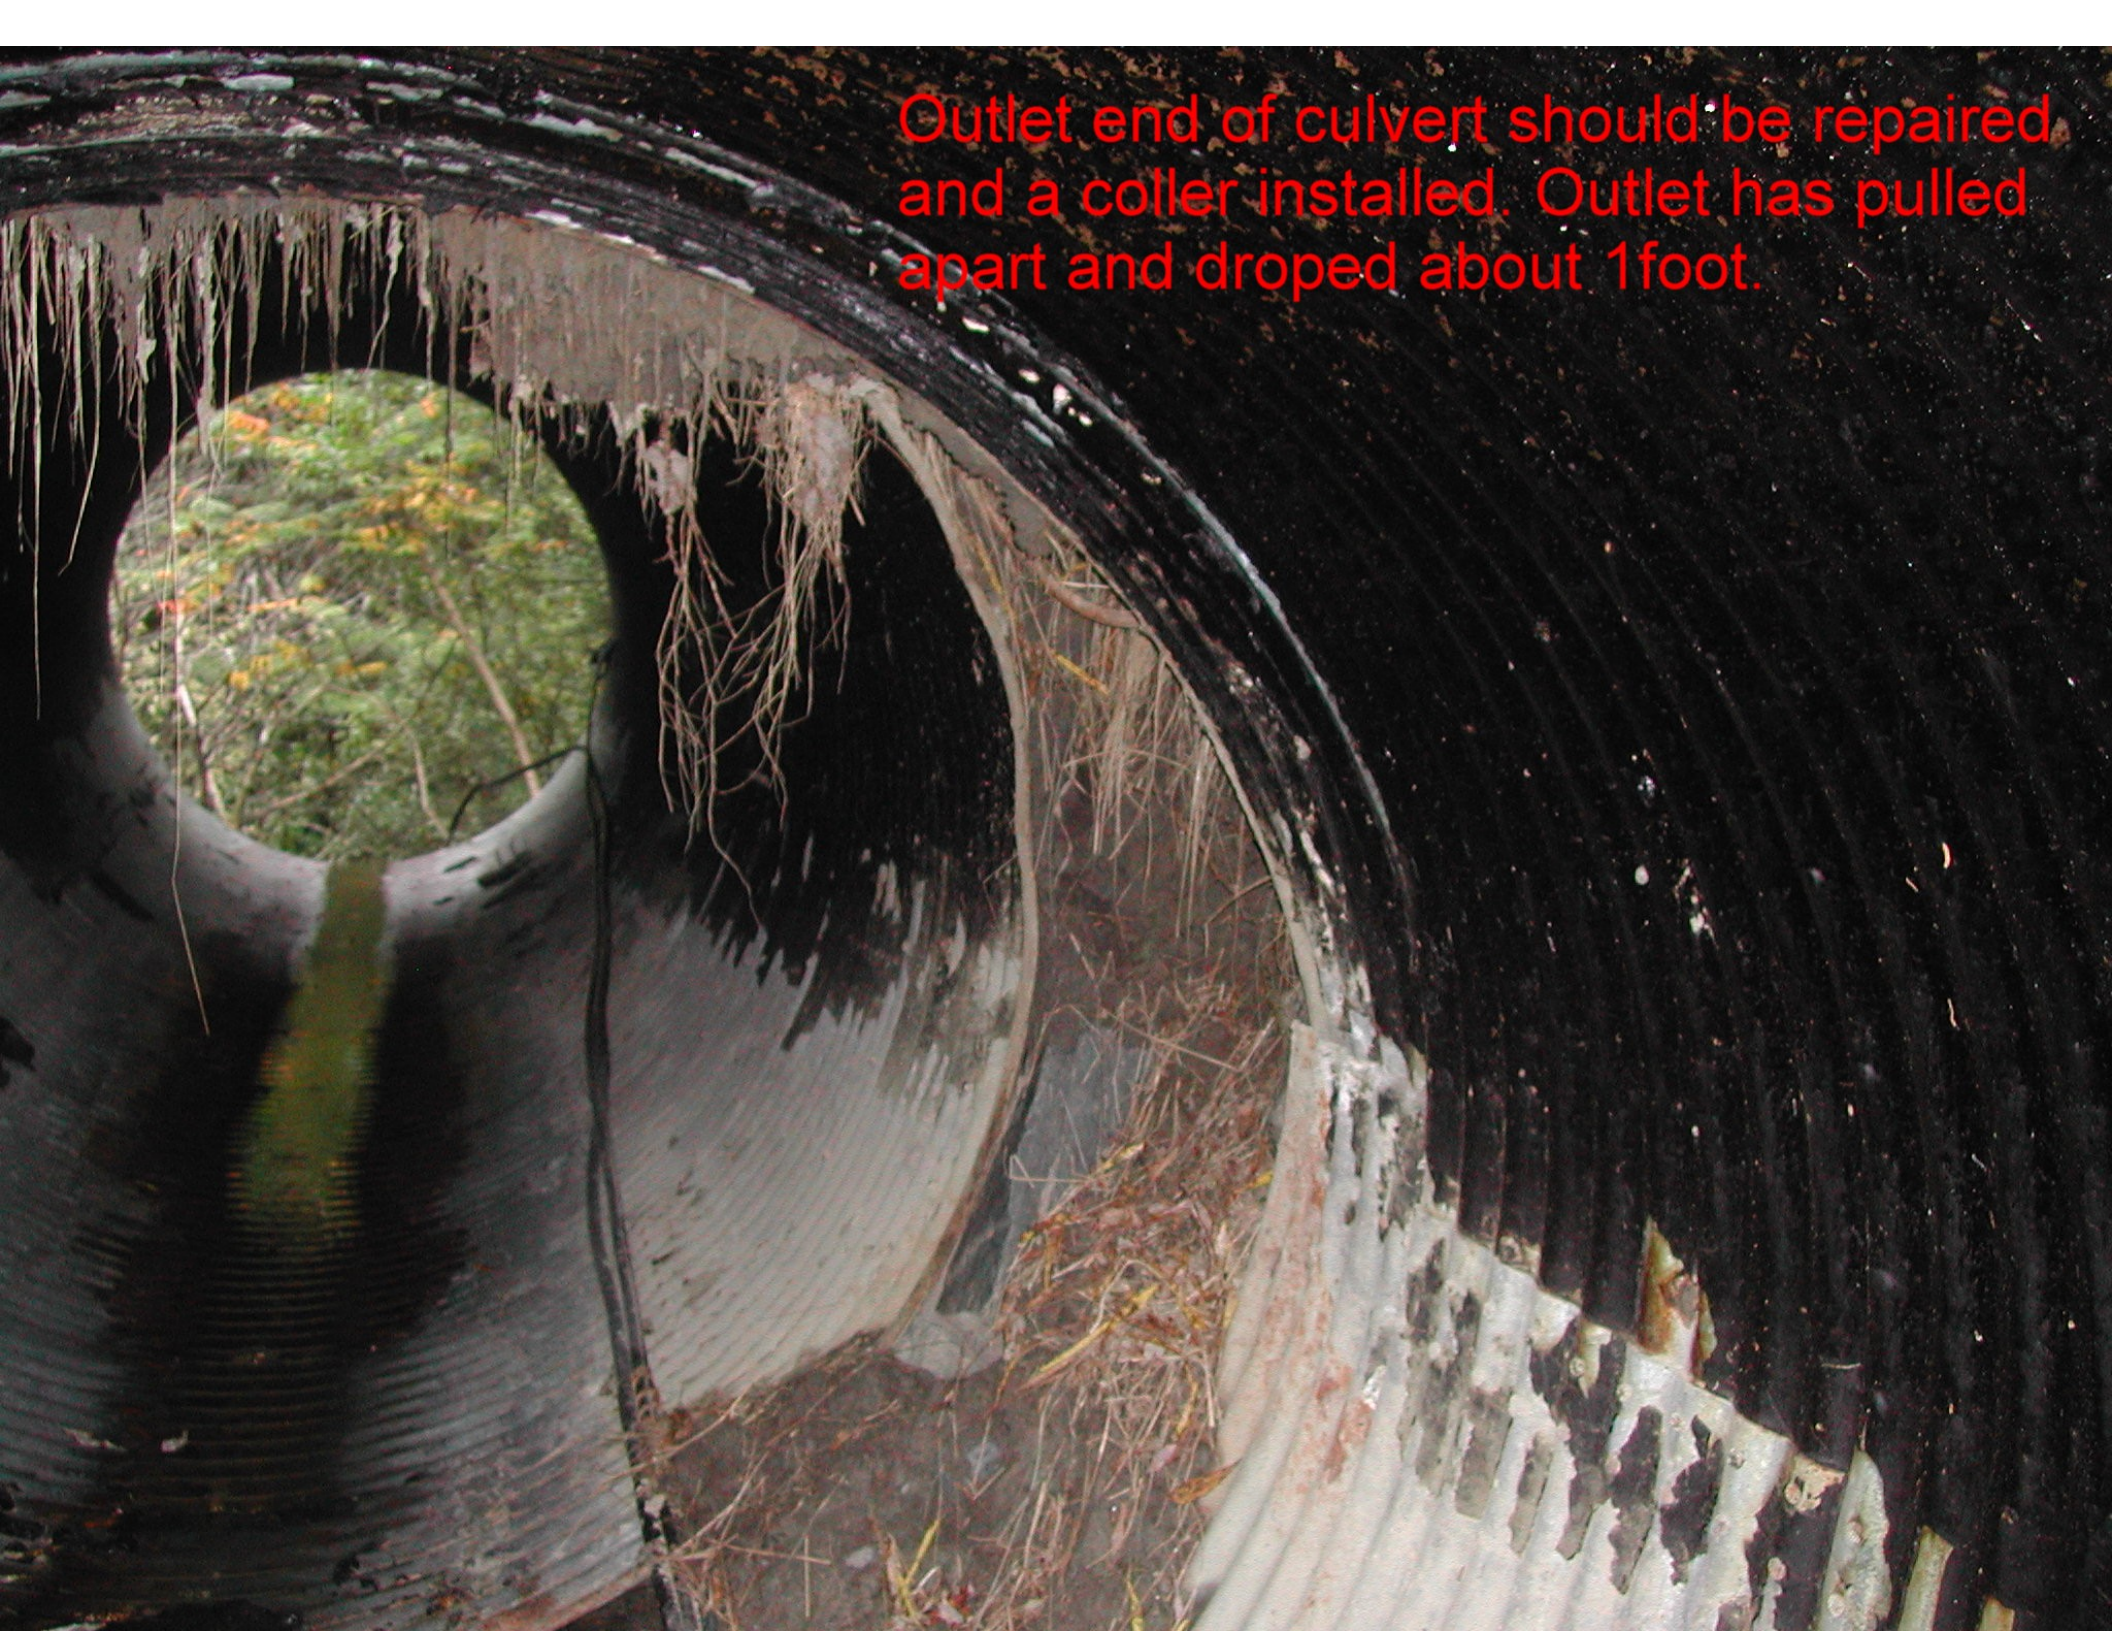
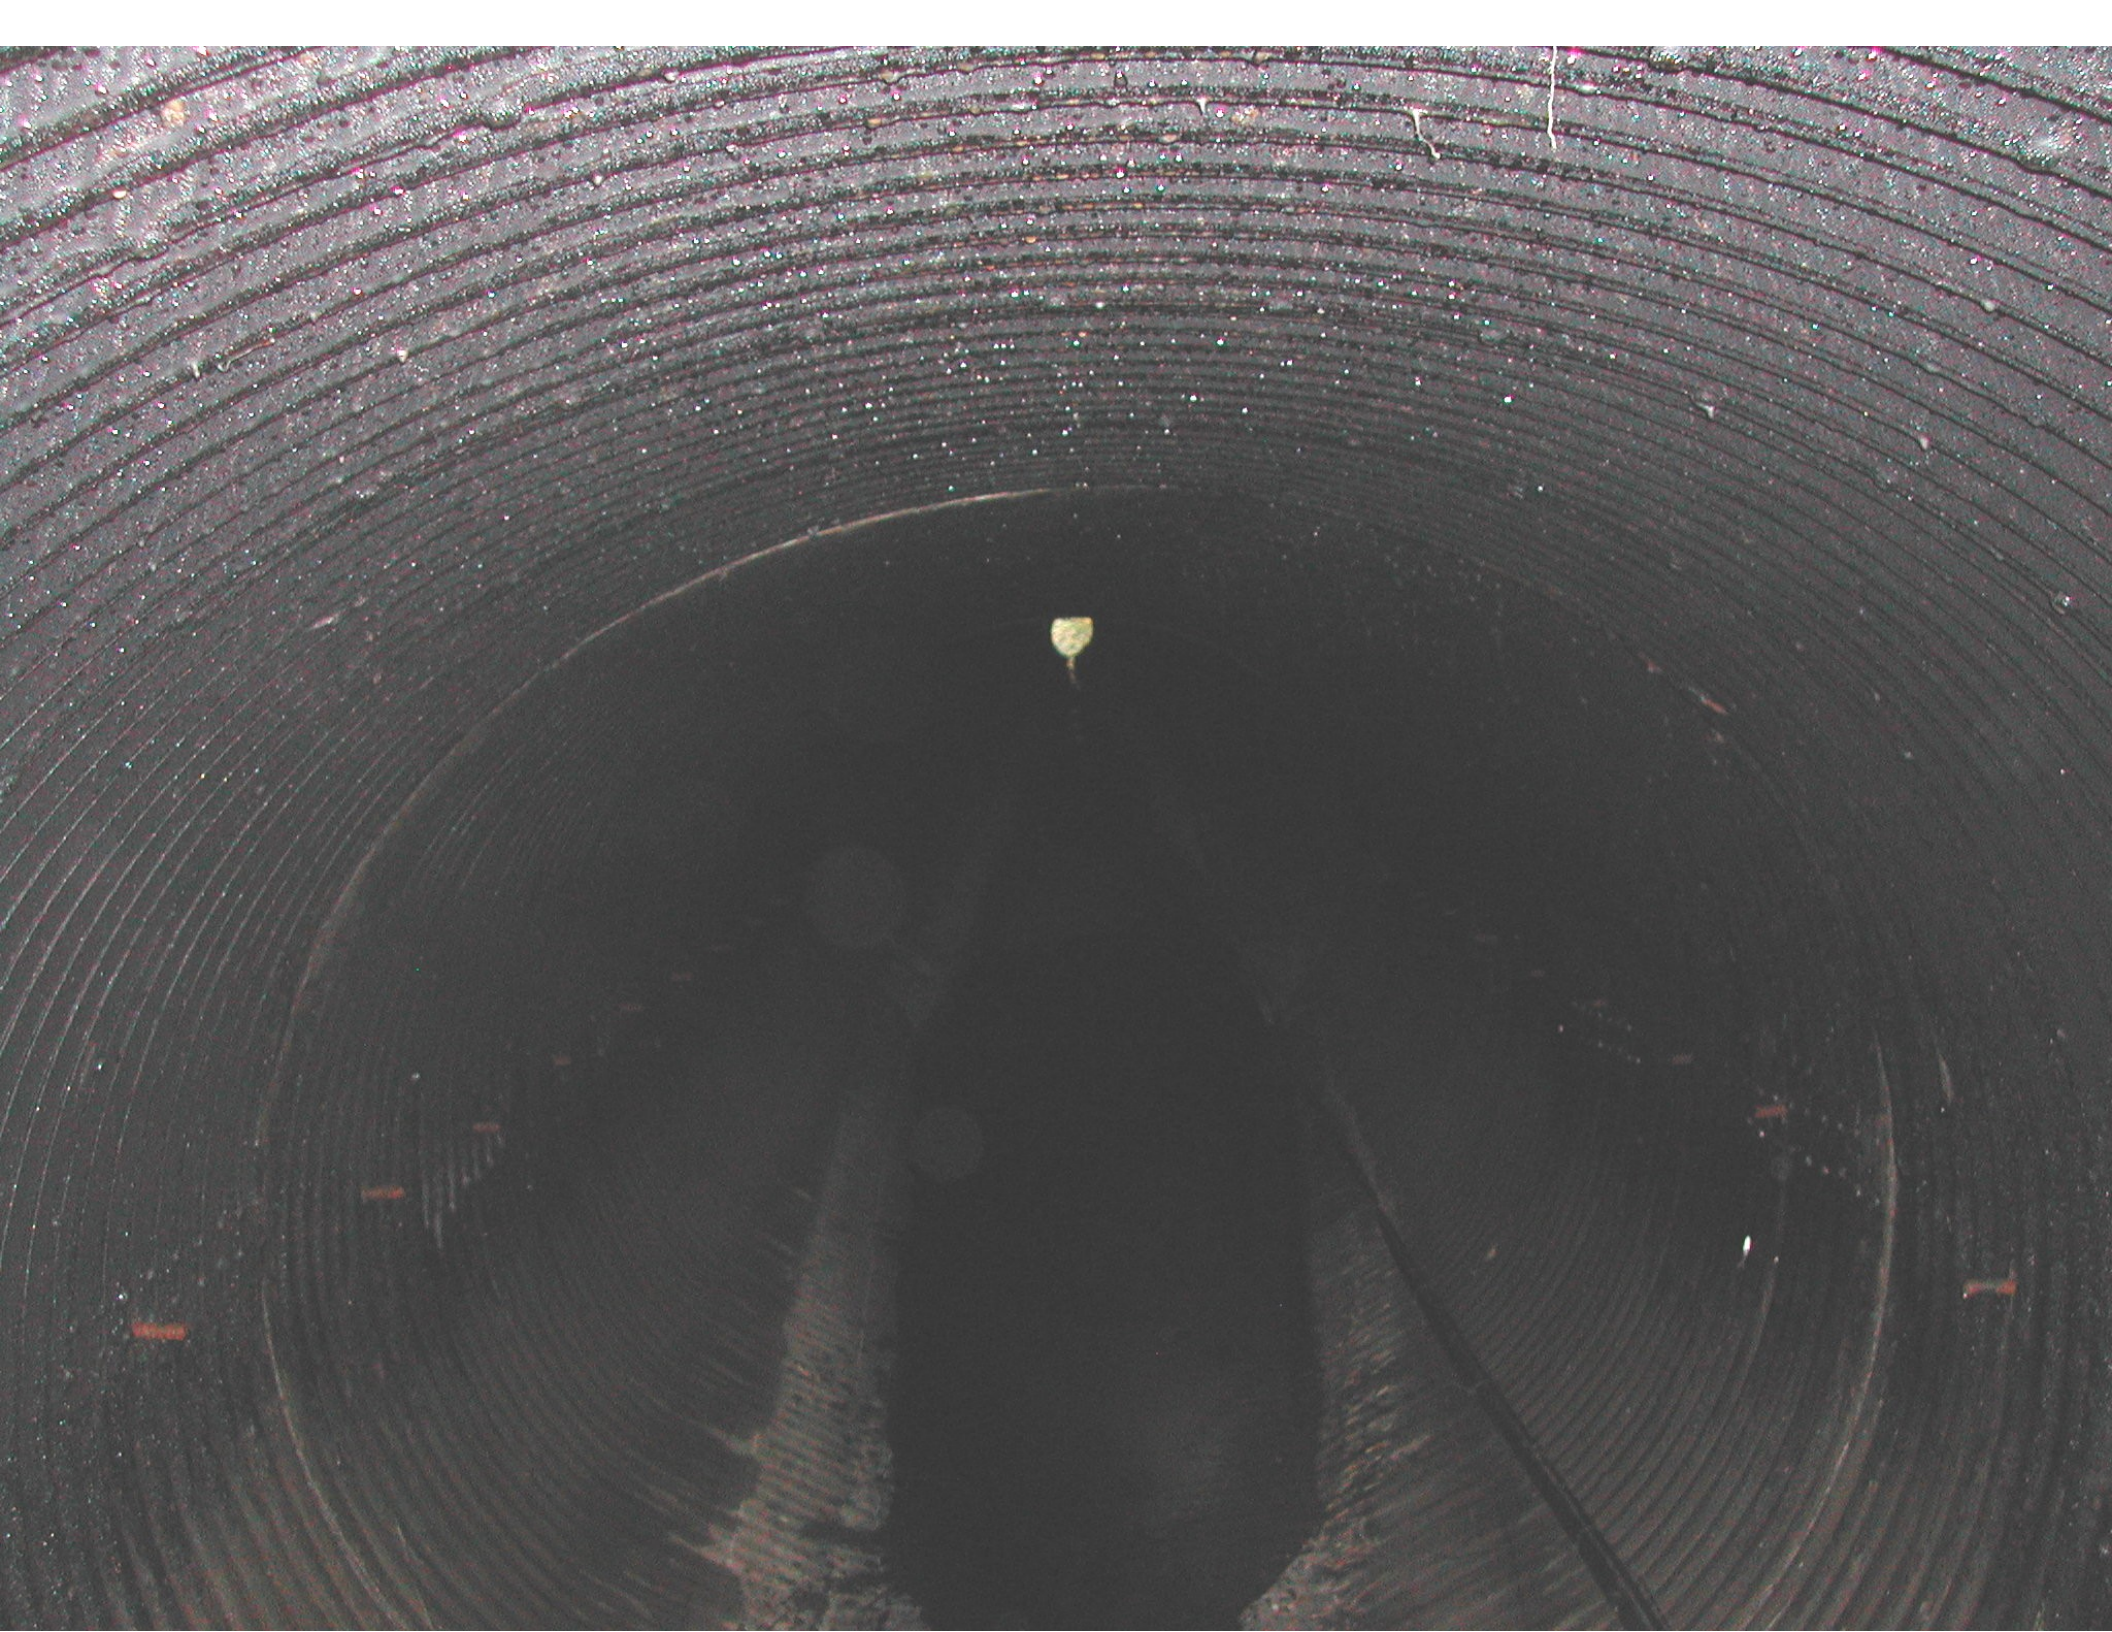
Outlet end of culvert should be repaired
and a collar installed. Outlet has pulled
apart and dropped about 1 foot.

Trees in channel at outlet need to be
